Subject: 10CFR21 Reporting of Defects and Non-Compliance
Thomas & Betts Printed Circuit Board P/N 90-41-974313

10CFR21 REPORTING OF DEFECTS AND NON-COMPLIANCE

COMPONENT: Thomas & Betts Printed Circuit Board P/N 90-41-974313

REPORT ID: 20100224_Notification_90-41-974313
File: 20100224_Notification_90-41-974313.doc

Figure 2, Jumper "WJ" correctly installed

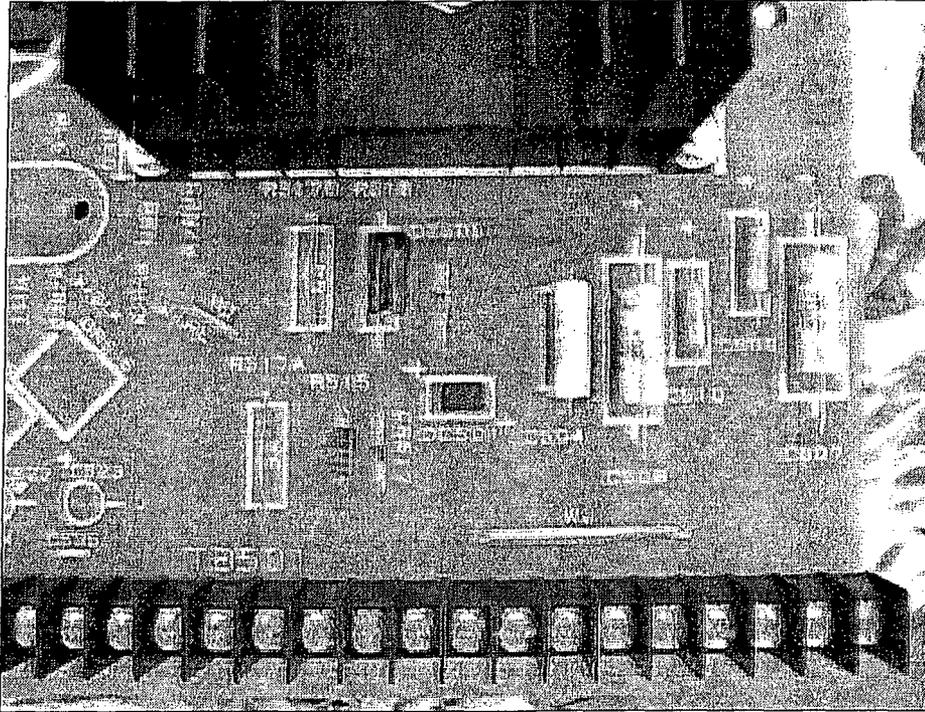
1. See figure 1 below for a picture of the Cyberex logic power supply board, p/n: 90-41-974313.
2. Inspect the board for a jumper at location "WJ". See figure 2 below.
3. If jumper at location "WJ" is missing, as shown in figure 3, then notify UCI and an RMA will be issued for the repair.

1. There are four suspect circuit boards that have been shipped to PSEG (Hope Creek Nuclear Station) that need to be inspected for the correct jumper per attachment 1. If found to be missing the jumper, then the boards need to be returned to UCI for jumper installation and retesting.
